In response to your request dated August 6, 1976, and a supplement thereto dated October 15, 1976, the Commission has issued the enclosed Amendment No. 33 to Facility Operating License No. DPR-30 for Unit No. 2 of the Quad Cities Nuclear Power Station.

This amendment (1) authorizes operation with additional 8 x 8 fuel assemblies, (2) incorporates revised MAPLHGR and MCPR limits in response to the plant specific analysis for reload 2 and (3) modifies License Condition 3.C to reflect End-of-Cycle scram reactivity conditions for reload 2.

AMENDMENT TO FACILITY OPERATING LICENSE

Amendment No. 33
License No. DPR-30

FIGURE 3.5-1 (Sheet 1 of 2)

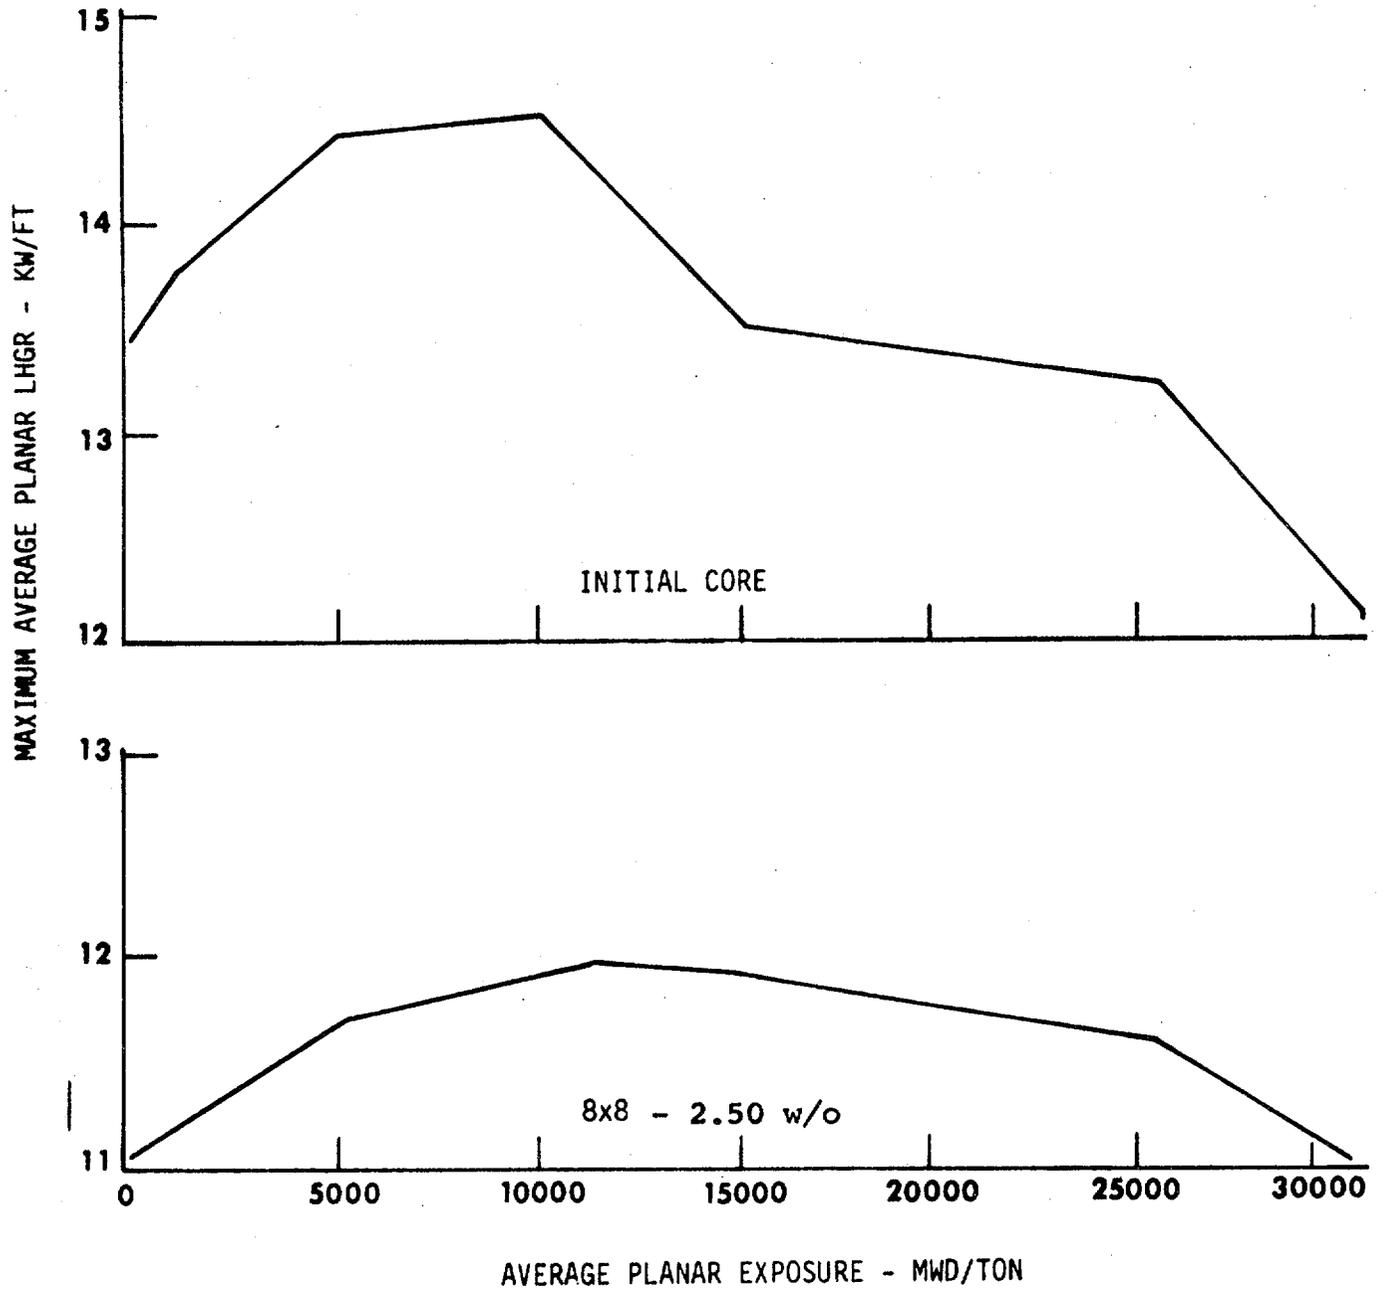
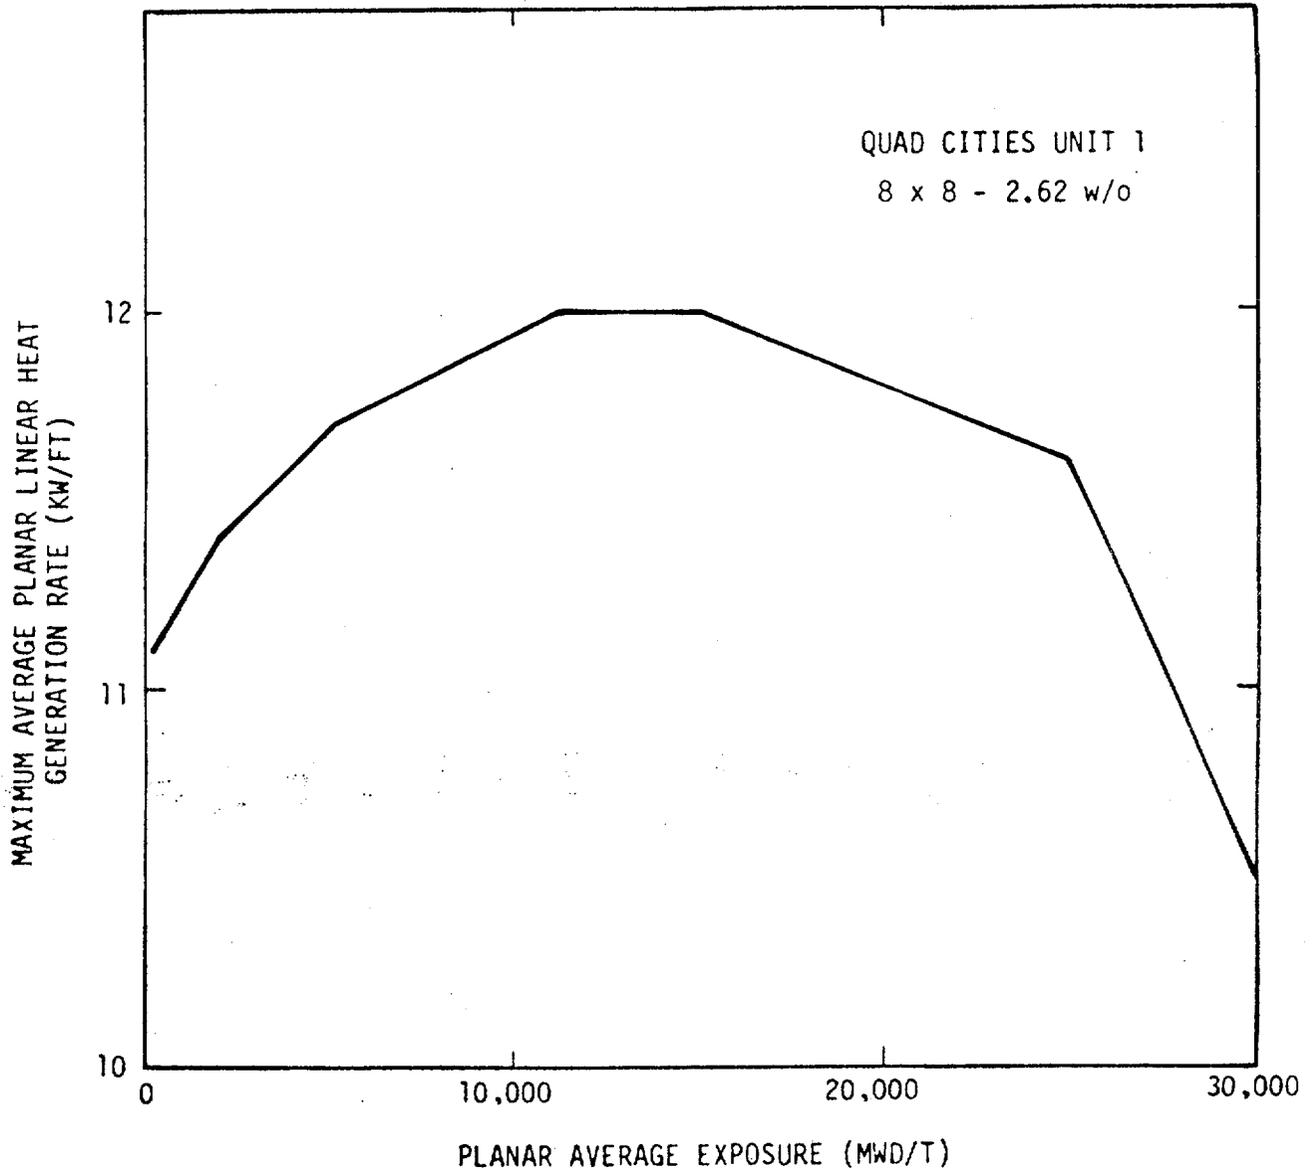
- (1) with additional 8 x 8 fuel assemblies (Reload-2), as requested in their application dated August 6, 1976;
- (2) incorporating revised MAPLHGR and MCPR limits in response to the plant specific analysis for Reload 2; and
- (3) with License Condition 3.C modified to reflect end-of-cycle scram reactivity conditions for Reload 2.

Based upon the review of the analyses presented above we conclude that the operation of the reactor would meet the requirement of 10 CFR 50.46 provided that operation is limited to the maximum average planar linear heat generation rates (MAPLHGR) of Figure 3.5-1 of the Quad Cities 2 Technical Specifications for the initial core fuel and for the fuel type 8D250 and of Figure 6-7 of Reference 4 for the fuel type 8D262. It should also meet the requirement of a minimum critical power ratio (MCPR) greater than 1.18.
